CONTRACT CHANGE ORDER NO. __
SHEET ____ OF ____

MARK	DATE	DESCRIPTIONS	BY	CH'D	CCO
REVISIONS					
3	11/04/11	TOWER ELEVATOR EXTENSION	JNB	FS	203S2
2	08/26/11	ELEVATOR DETAILS	JNB	FS	85
1	07/17/09	ELEVATOR DETAILS	JNB	FS	85

SAN FRANCISCO OAKLAND BAY BRIDGE
EAST SPAN SEISMIC SAFETY PROJECT
SELF-ANCHORED SUSPENSION BRIDGE
(SUPERSTRUCTURE & TOWER)

ELEVATOR DETAIL NO. 2

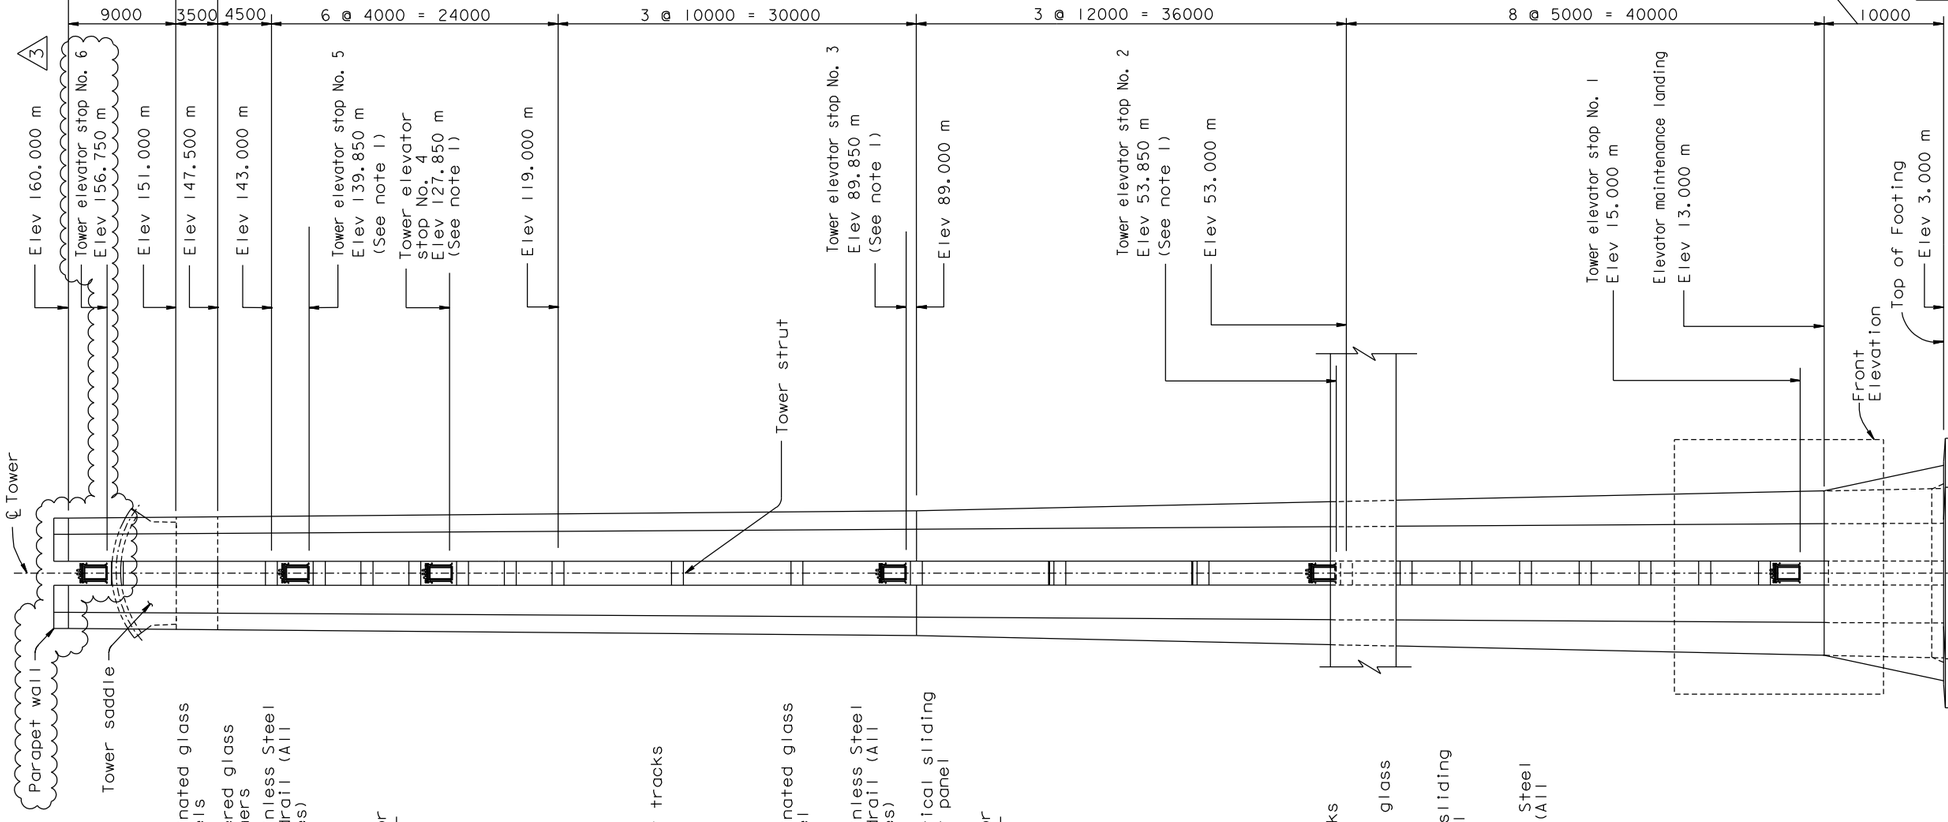
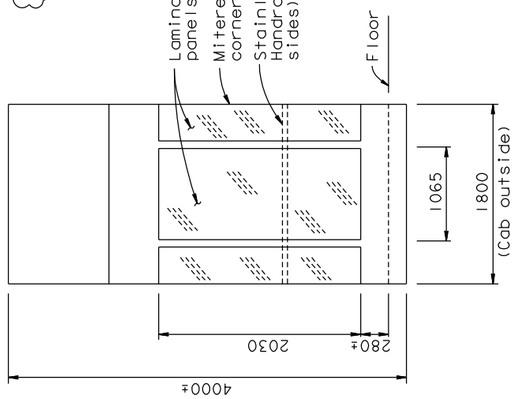
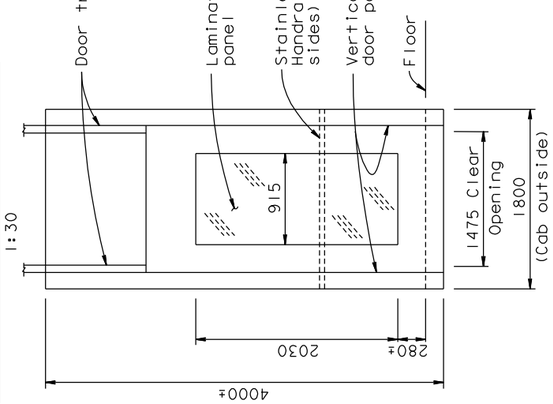
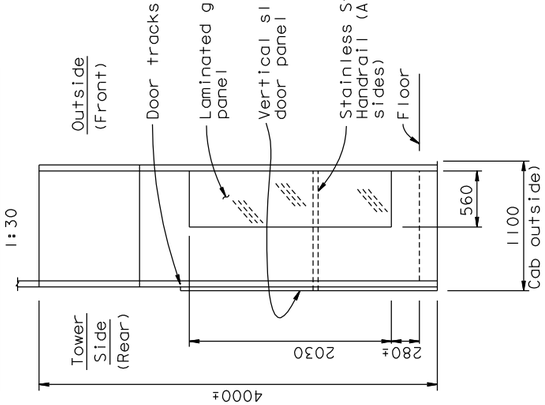
MARK	DATE	DESCRIPTIONS	BY	CH'D	CCO
		REVISIONS			
3	11/04/11	TOWER ELEVATOR EXTENSION	JNB	FS	203S2
2	08/19/11	ELEVATOR DETAILS	JNB	FS	85
1	07/17/09	ELEVATOR DETAILS	JNB	FS	85

PARAPET WALL AT TOWER HEAD DETAILS NO.1

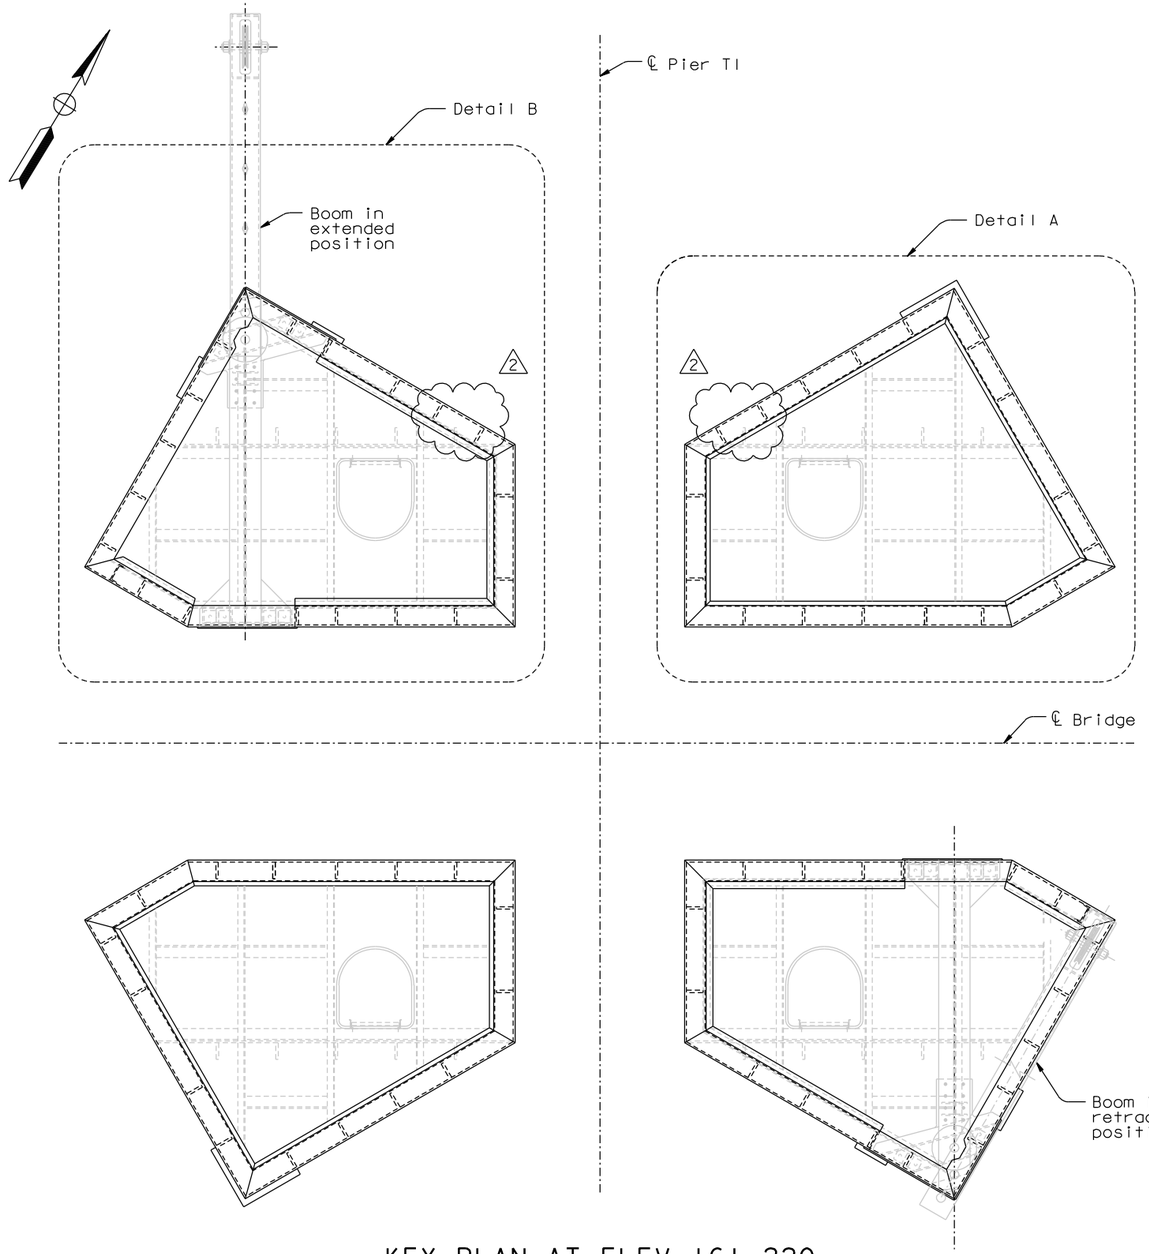
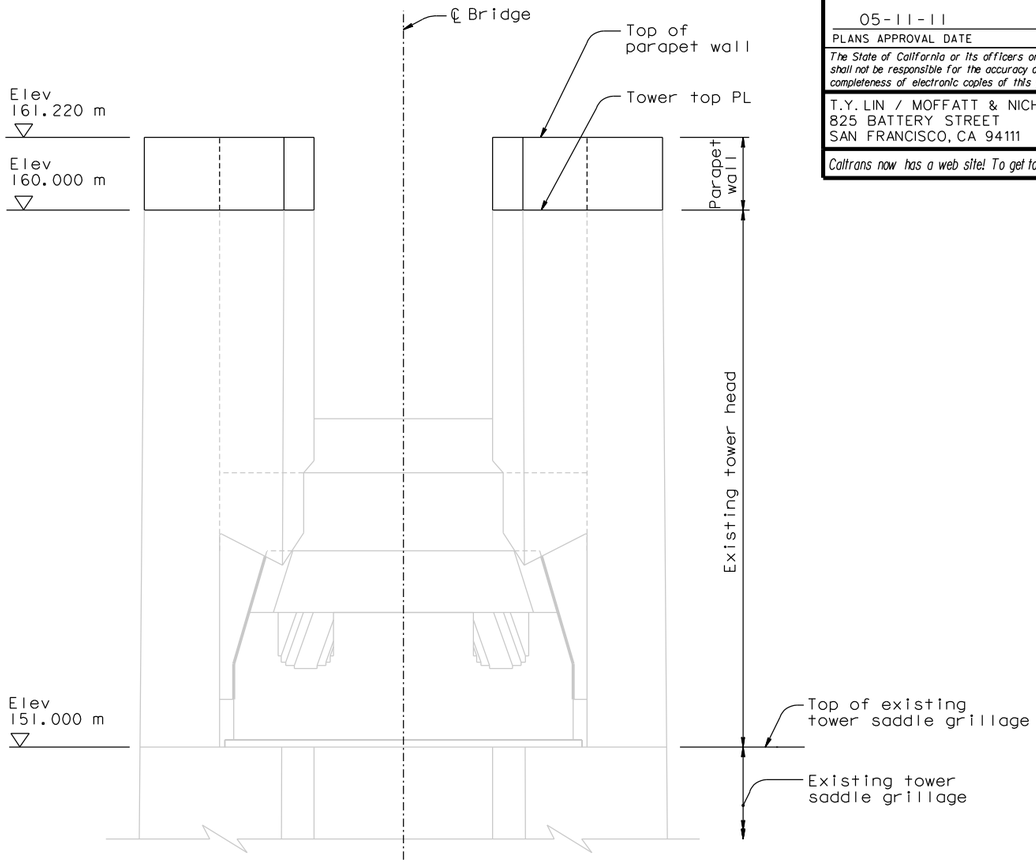
MARK	DATE	DESCRIPTIONS (REVISIONS)	BY	CH'D	CCO#
2	11/04/11	TOWER ELEVATOR EXTENSION	NV	MN	203S2
1	09/16/11	TOWER SUSPENDER CABLE & ELEVATOR	NV	MN	203S1
0	05/11/11	PARAPET WALL AT TOWER HEAD	NV	MN	196

PARAPET WALL AT TOWER HEAD DETAILS NO. 2

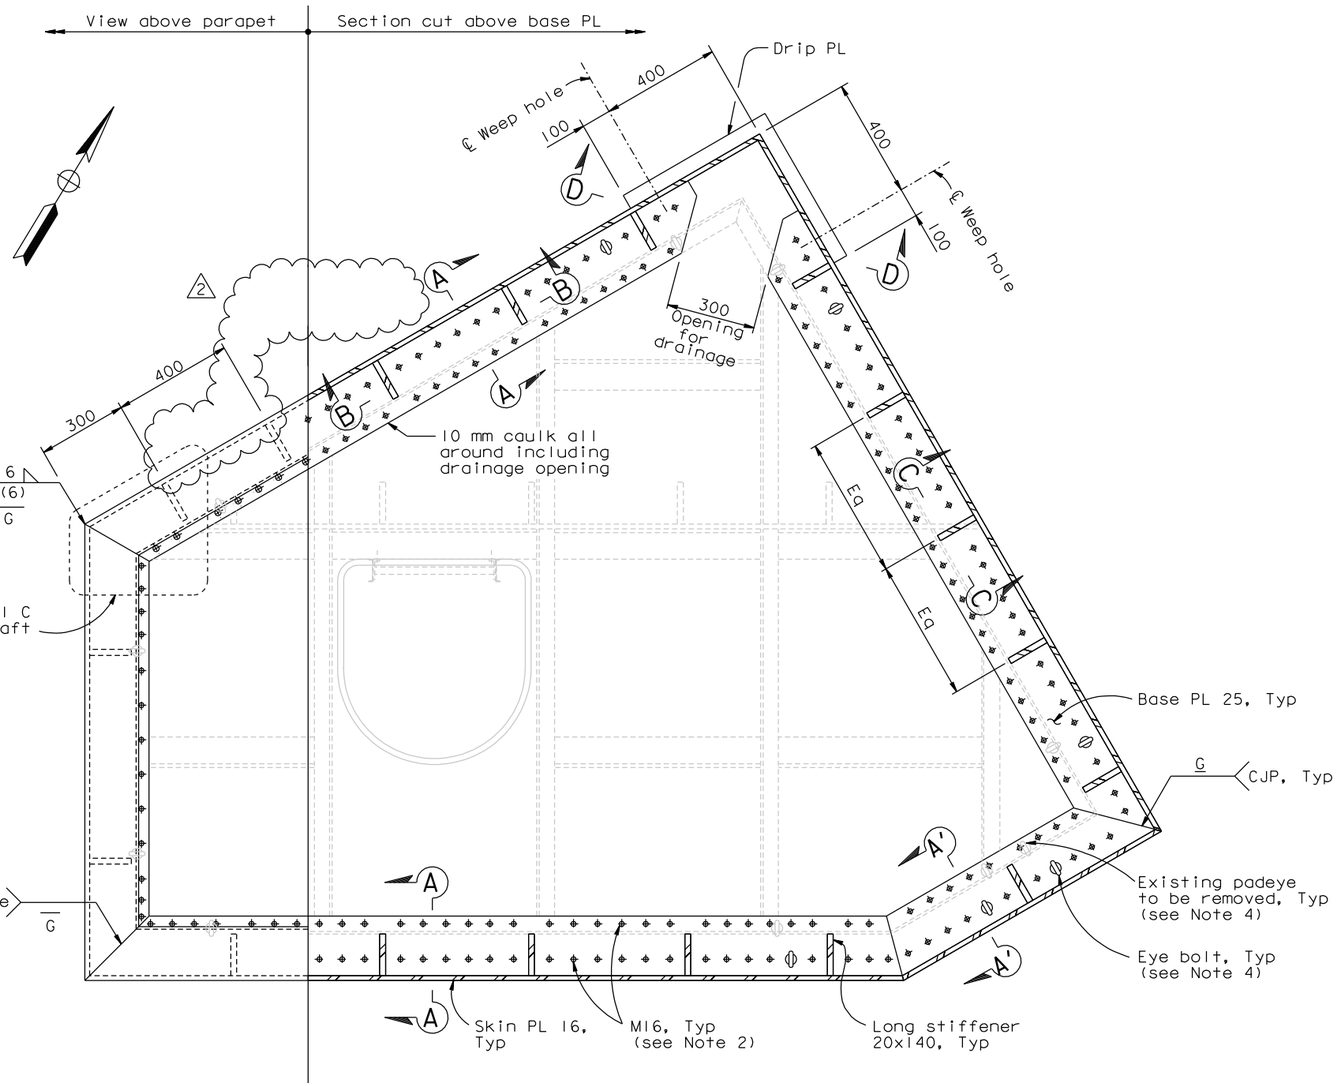
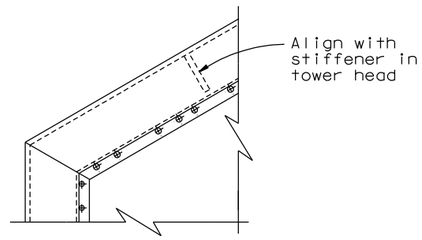
1. For Sections A-A, A'-A', B-B, C-C and D-D, see "Parapet Wall At Tower Head Details No. 3" sheet.
2. At the Contractor's option, 5/8 inch Dia A325 HS bolts may be used in lieu of M16 A325M bolts.
2. 3. Note deleted.
4. Replace each existing padeye to be removed as follows:

MARK	DATE	DESCRIPTIONS	BY	CH'D	CCO#
2	11/04/11	TOWER ELEVATOR EXTENSION	NV	MN	203S2
1	09/16/11	TOWER SUSPENDER CABLE & ELEVATOR	NV	MN	203S1
0	05/11/11	PARAPET WALL AT TOWER HEAD	NV	MN	196

Install 16 mm Dia x 100 mm long Crosby forged shoulder eye bolt or equivalent at location shown in the base plate (must be between 2 HS bolts and not adjacent to stiffener). Spacer plate shall be provided to ensure full thread engagement of the nut. Nut shall be installed snug-tight. Jam nut or lock nut shall be used to prevent bolt nut from backing off. See Section A'-A'.

Install Crosby No. 4 padeye or equivalent as close to skin plate and adjacent stiffener as possible with the required clearance for all-around welding of padeye to base plate.

PARAPET WALL AT TOWER HEAD DETAILS NO. 4

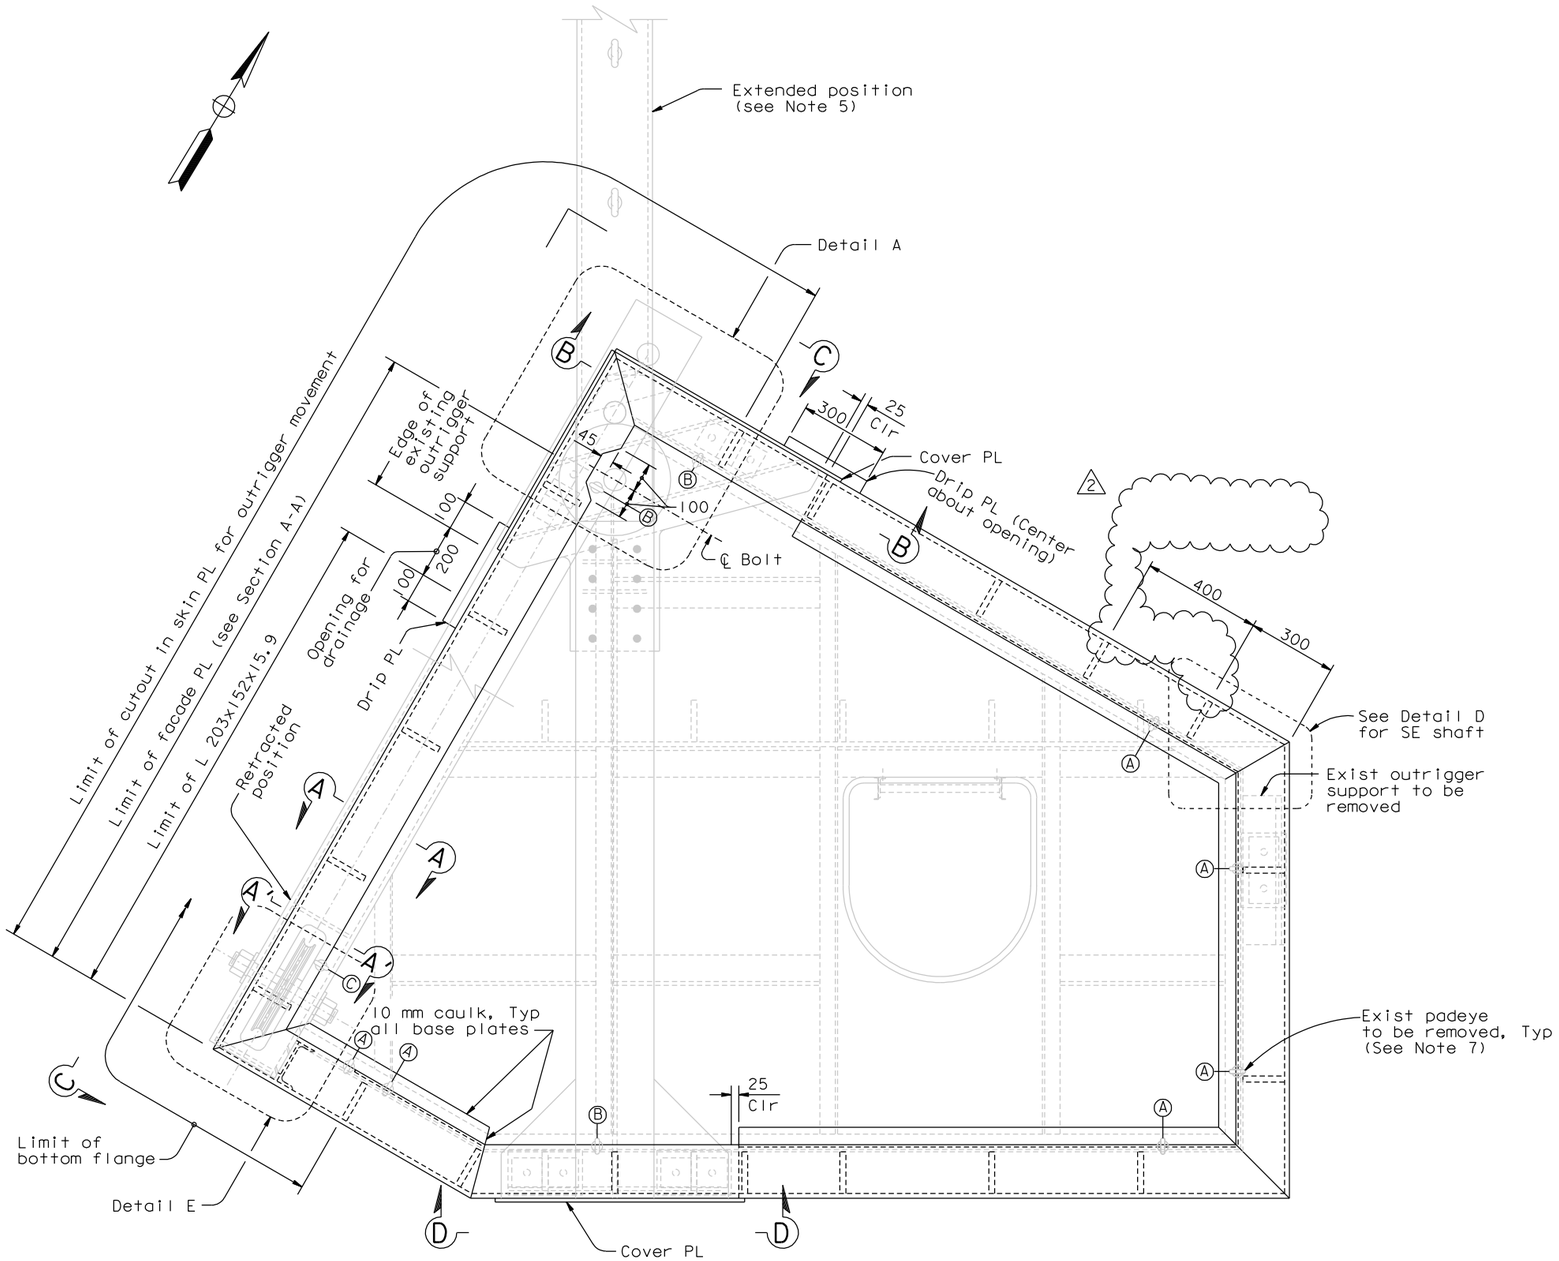
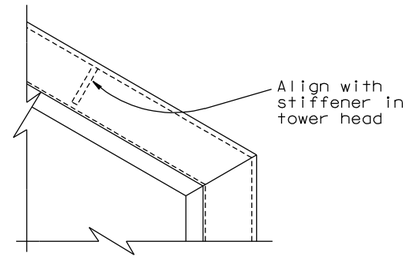
△2
6. Note deleted.

MARK	DATE	DESCRIPTIONS	BY	CH'D	CCO#
△2	11/04/11	TOWER ELEVATOR EXTENSION	NV	MN	203S2
△1	09/16/11	TOWER SUSPENDER CABLE & ELEVATOR	NV	MN	203S1
△0	05/11/11	PARAPET WALL AT TOWER HEAD	NV	MN	196

7. For details and locations of relocated padeyes:
   - Ⓐ - See Note 4 on "Parapet Wall At Tower Head Details No.2" sheet.
   - Ⓑ - See Note 5, this sheet.
   - Ⓒ - See Section A'-A' on "Parapet Wall At Tower Head Details No.5" sheet.

TOWER ELEVATOR SUPPORT DETAILS NO.1

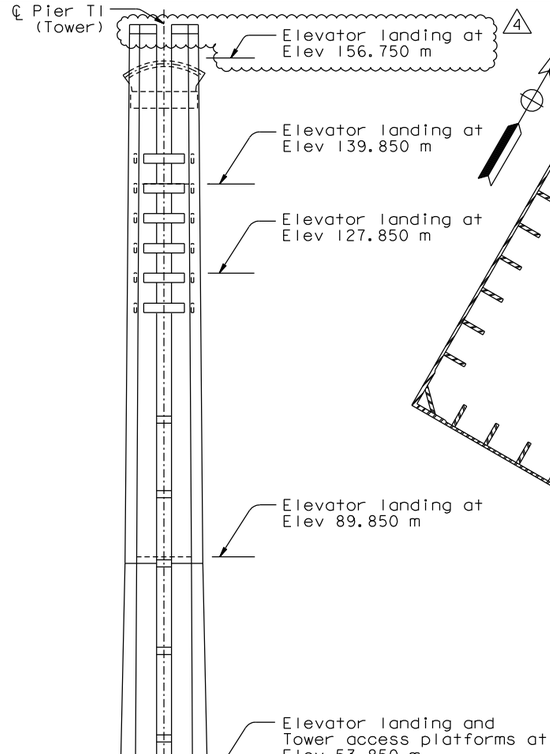
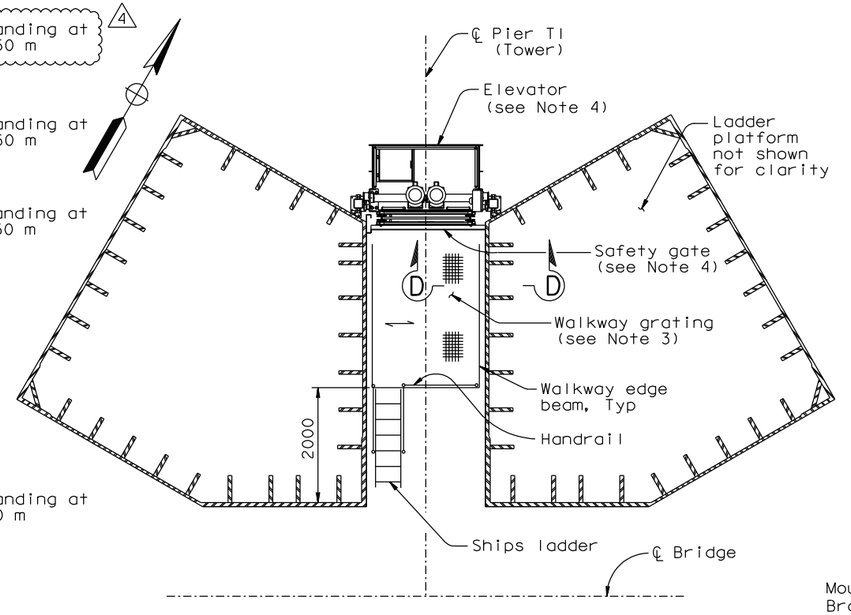
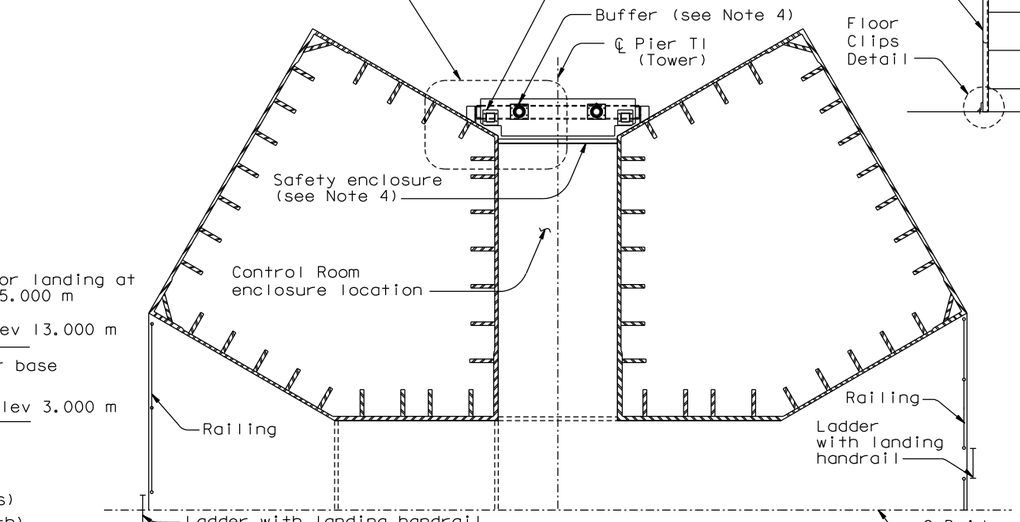
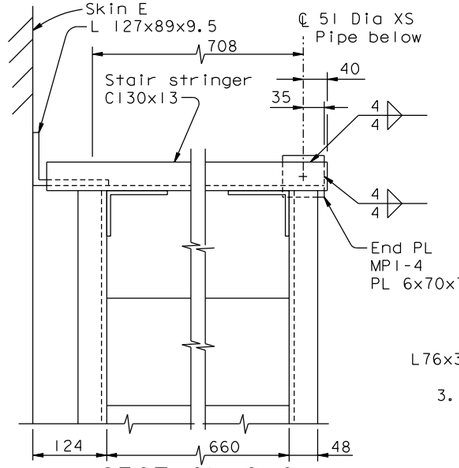
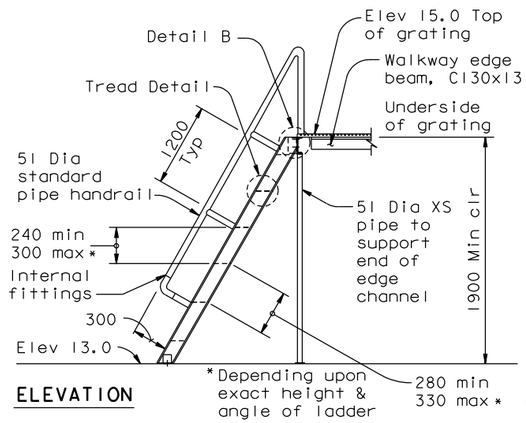
MARK	DATE	DESCRIPTIONS	BY	CH'D	CCO#
4	11/04/11	TOWER ELEVATOR EXTENSION	TH	MN	203S2
3	08/19/11	ELEVATOR DETAILS	TH	MN	85
2	10/15/10	HANDRAIL AND PLATFORMS	TH	MN	114
1	07/17/09	ELEVATOR DETAILS	TH	MN	85

9. At the Contractor's option, C130x10.4 may be used for the platform grating support beam at top of stairway only.
10. For elevator landing details at Elevation 156.750, see "Tower Access Details No.31" sheet.
